**BEFORE THE
LOUISIANA PUBLIC SERVICE COMMISSION**

DOCKET NO. I-36242

**SOUTHWESTERN ELECTRIC POWER COMPANY,
EX PARTE**

STAFF REPORT AND RECOMMENDATIONS

Figure 3. New supply resources, by optimized portfolio 2024-2043

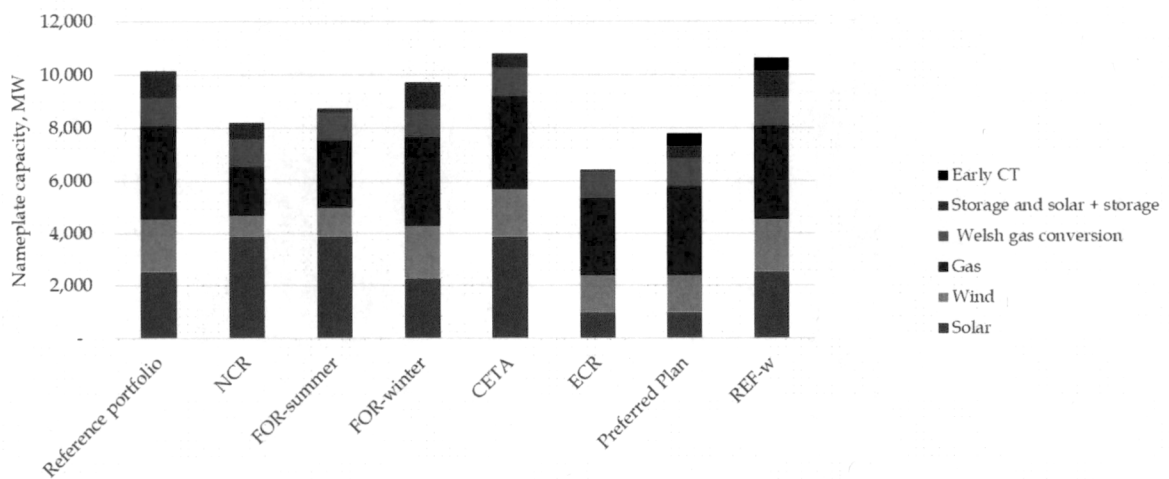
SWEPCO used the AURORA model to select an optimal portfolio of resources to meet projected load under several market scenarios (Reference, NCR, FOR, CETA, and ECR). Each of these portfolios is considered “optimal” in the sense that each one is optimized relative to the market scenario for which it was designed.³⁸ SWEPCO’s resource portfolios result in a range of less than 7,000 MW to over 10,000 MW of new (nameplate) capacity additions (see Figure 3). This range includes SWEPCO’s Preferred Plan, which will be discussed in more detail below.
